Title - Sujet Toad River Maint. Camp Remediation	
Solicitation No. - N° de l'invitation EZ113-171201/A	Amendment No. - N° modif. 003
Client Reference No. - N° de référence du client	Date 2016-09-15
GETS Reference No. - N° de référence de SEAG PW-\$PWY-022-7858	
File No. - N° de dossier PWY-6-39129 (022)	CCC No./N° CCC - FMS No./N° VME
Solicitation Closes - L'invitation prend fin at - à 02:00 PM on - le 2016-09-28	Time Zone Fuseau horaire Pacific Daylight Saving Time PDT
F.O.B. - F.A.B. Plant-Usine: <input type="checkbox"/> Destination: <input checked="" type="checkbox"/> Other-Autre: <input type="checkbox"/>	
Address Enquiries to: - Adresser toutes questions à: Arthur (PWY), Carolyn	Buyer Id - Id de l'acheteur pwy022
Telephone No. - N° de téléphone (604) 364-2752 ()	FAX No. - N° de FAX (604) 775-6633
Destination - of Goods, Services, and Construction: Destination - des biens, services et construction: PWGSC - Toad River Maintenance Camp - Alaska Hwy, BC

Toad River Maintenance Camp Remediation

This Amendment 003 is raised to:

The following changes in the tender documents are effective immediately. This addendum will form part of the contract documents.

SNC • LAVALIN	
CLIENT NAME: RED PUBLIC WORKS AND CONSERVATION SERVICES CANADA	PROJECT LOCATION: TOAD RIVER ALASKA HIGHWAY, BC
CONTAMINATED MATERIAL EXTENTS	
DWN BN: BB CH2C: AD	SCALE: 1:1,000 FLOOR: 20160914.1416 DATE/FILE: 63574486
	DWG NO: 1 635734-303 REV.:

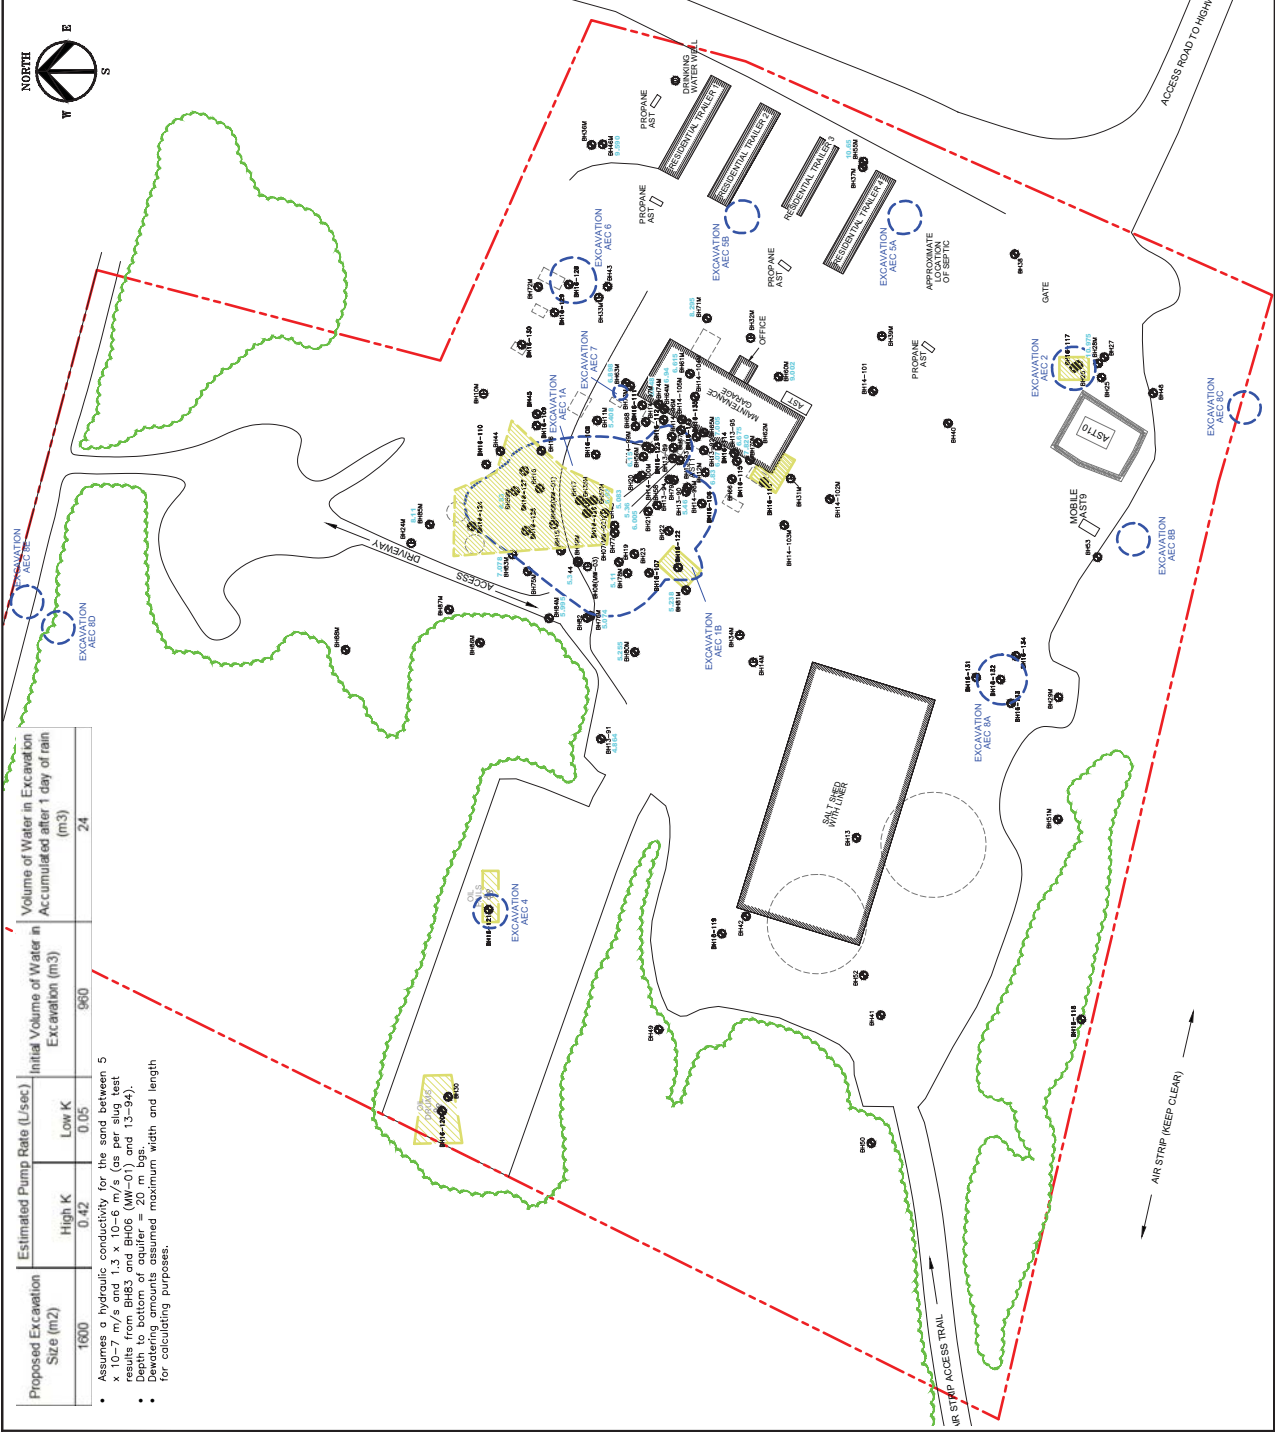
Drawings revised for elimination of excavation AEC 1C from scope.

2. Drawing 635734-303

Replace with attached Drawing 635734-303

SIN: BB SCALE: 1:900 DATE: 2016-08-09 DWG. NO: **635734-304**

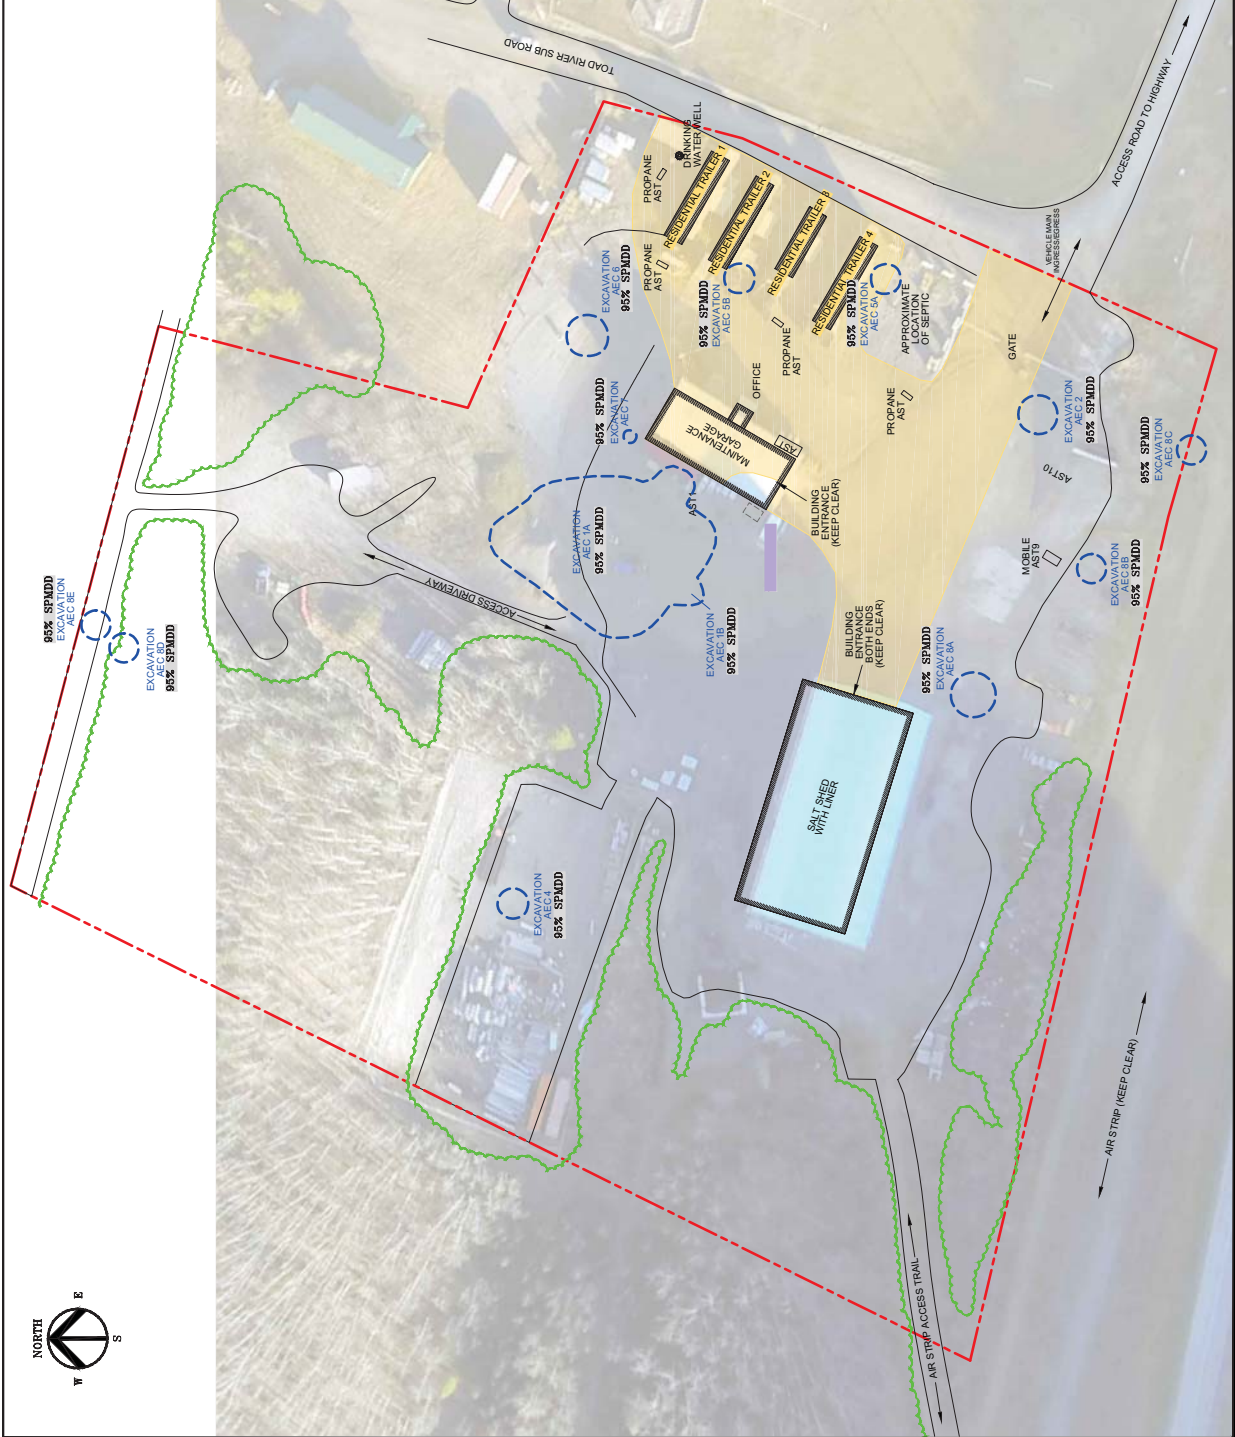
3. Drawing 635734-304

Replace with attached Drawing 635734-304
